RE: Submission - MP06\_0162 MOD 8 - Modifications to Barangaroo Concept Plan

Submission to NSW Planning Barangaroo Modification #8

## State Environmental Planning Policy Amendment (Barangaroo) 2015

Attachment A – Mod 8 Masterplan SEPP Maps Land Zoning Map

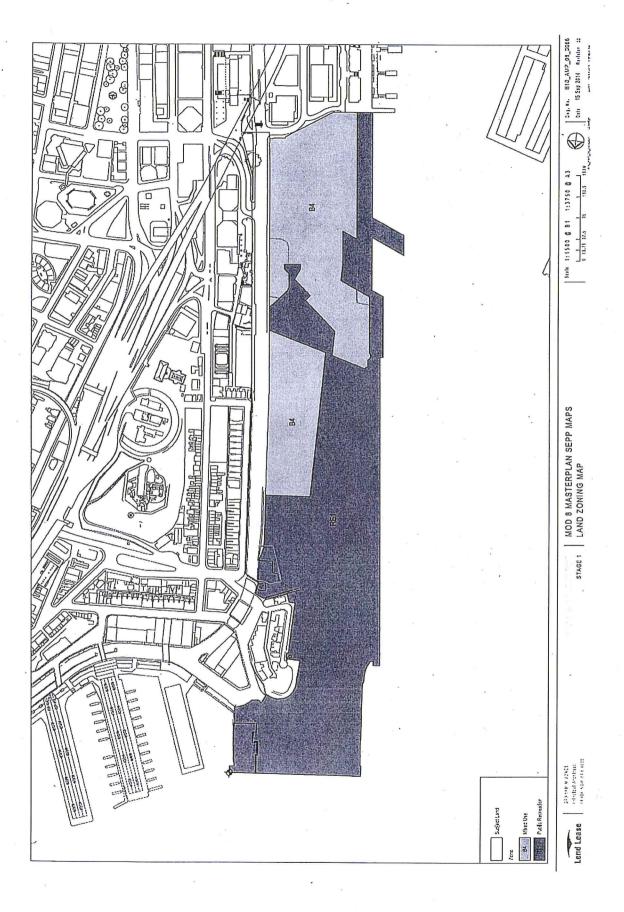
The exhibition material associated with the Modification 8, specifically Appendix I of the Environmental Assessment Report (EAR) depicts an RE1 Public Recreation zone over the subject site (see Attachment A). However, the proposed land zoning map which accompanies the exhibition material for the State Environmental Planning Policy (Major Development) 2005 amendment retains the B4 Mixed Use zoning over the site (see Attachment B).

From discussions between Primary Health Care and the Barangaroo Redevelopment Authority, it is understood that it is not the intention of the modification application to rezone the site to RE1 Public Recreation as shown in the EAR exhibition material. This position appears consistent with the content of Modification 8 where there is no strategic justification for a rezoning of the Dalgety Bond Store site:

To avoid any doubt, we request that Appendix I of the EAR be modified as part of and preferred project report or submissions report so that the map in the EAR is consistent with the current zoning map under State Environmental Planning Policy (Major Development) 2005. This would require amending this map as follows:

The subject site (Lot 100 in DP 838323) shown as B4 Mixed Use.
